# PLANNING BOARD REPORT PORTLAND, MAINE

Seaport Lofts (Bay House Phase II)  
101-121 Newbury Street and 40 Hancock Street  
Level III Site Plan and Subdivision Review  
2013-179  
113 Newbury Street, LLC, Applicant

Submitted to: Portland Planning Board	Prepared by: Nell Donaldson, Planner
Public Hearing Date: October 22, 2013	Date: October 17, 2013
Planning Board Report Number: #46-13	CBLs: 20-D-13, 14, 15, 32

Figures 4, 5, 6, and 7: Revised elevations, showing changes in window and door design, Newbury Street canopy, and façade composition.

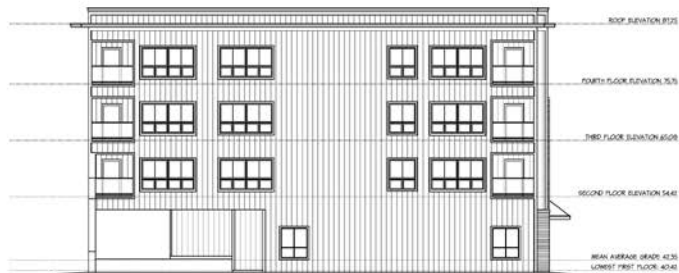
Responding to staff requests, the applicant has made some effort to enhance the building entrances. The door of the main, shared entry on Newbury Street has been pulled out to the face of the building. The architect has also altered the awning in this area to represent a more contemporary style. The details of the awning design remain to be resolved. In addition, a Hancock Street awning, while newly added, is shown in the original style. The city has asked the architect to revise the awning in this area to match that on the Newbury Street façade.

The applicant has revised the floor plans to square the northwest corner, adding floor area to the upper story units and changing the window and balcony configuration in this area. Because of the parking arrangement below, this results in a post which is out of alignment with the building above. The rear elevation shows how this corner post will be treated.

In response to repeated comments about the flatness of the building, the applicant has altered the composition of the Newbury street façade, alternating between brick and metal cladding on the third floor, to provide some vertical accentuation, visual interest, as well as definition for the main entrance. The applicant has also changed the material configuration on the west end and the posts at the building’s rear. Staff has requested that the architect add a soldier course at the top of the second floor in order to rationalize the change in composition there, where the townhouse units meet the upper story flats.

Window mullions were added, and the openings on the west elevation have been reconfigured slightly; they now match the scale of the window openings above. On the rear of the building, the applicant has reduced the size of the balconies and added windows.

Figure 5: Proposed Hancock Street elevation

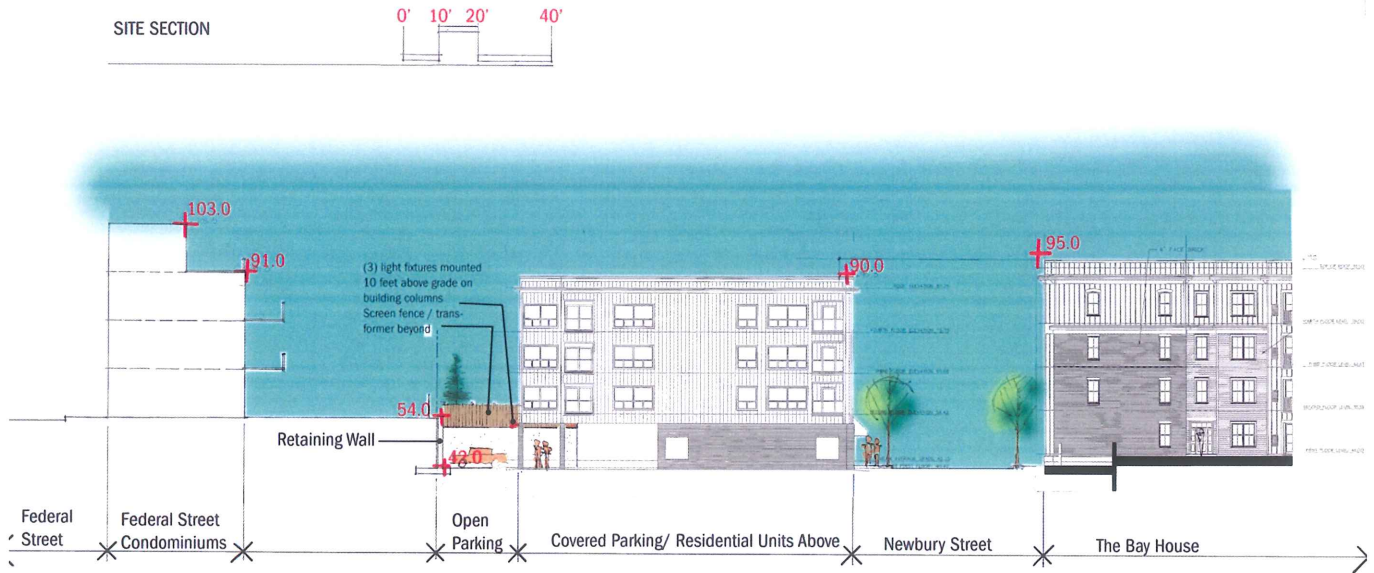
Figure 5 below shows the proposed Hancock Street grade elevations. Much of the shadow impact from the Seaport Lofts would fall on the northerly residential buildings, although this would be mitigated slightly by the elevation change toward Federal Street. There would be no shadow impacts to publicly accessible open spaces. Per the Technical Manual, a shadow study is not required for Level II or III developments that are less than 45 feet tall (*Section 11.3*). Though the height remains to be verified by the zoning administrator, it is the applicant’s intent that the building meet the zoning height limit.
